**ASCE-INDOT
STRUCTURAL SUBCOMMITTEE
MEETING NO. 36 MINUTES
June 7, 2007**

3. Tony Uremovich led a discussion with regards to the impacts that the JTRP recommendations on Integral End Bent Structures will have on the current Indiana Design Manual. These recommendations can be referenced from the October 5, 2006 meeting minutes Item No. 3.

SUGGESTED INTEGRAL END BENT DETAILS
 (Beams Attached to Concrete Cap, Method B)
 Figure 67-1C

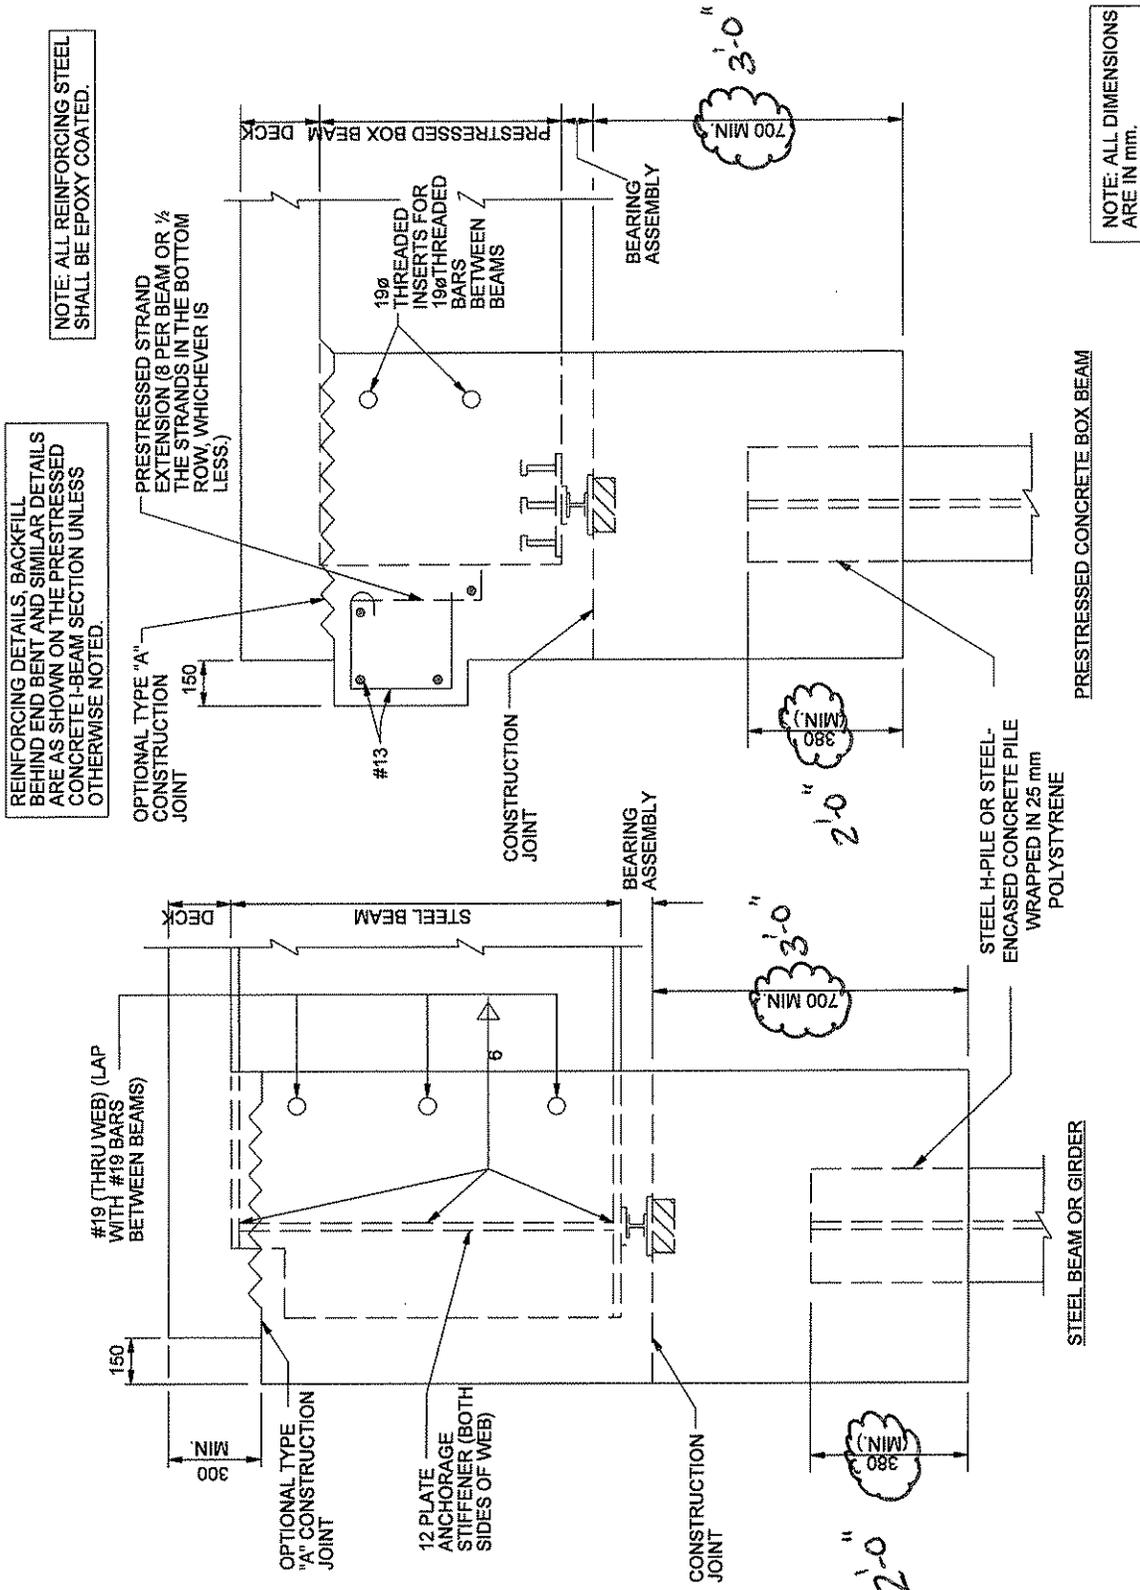
- A. Pile embedment increased to 24 inches. Figure 67-1C (Attachment 1A) will be revised. The vertical dimension from the bottom of the end bent to the construction joint will be revised from 700 mm to 925 mm (3'-0"). Revise Section 67-1.01(06) Item No. 2 (Attachment 1B).

1. Width. The end bent width shall not be less than 750 mm.
2. Cap Embedment. The piling shall extend a minimum of 600 mm into the cap, ~~if using Method A, and a minimum of 375 mm if using Method B.~~ (2'-0")
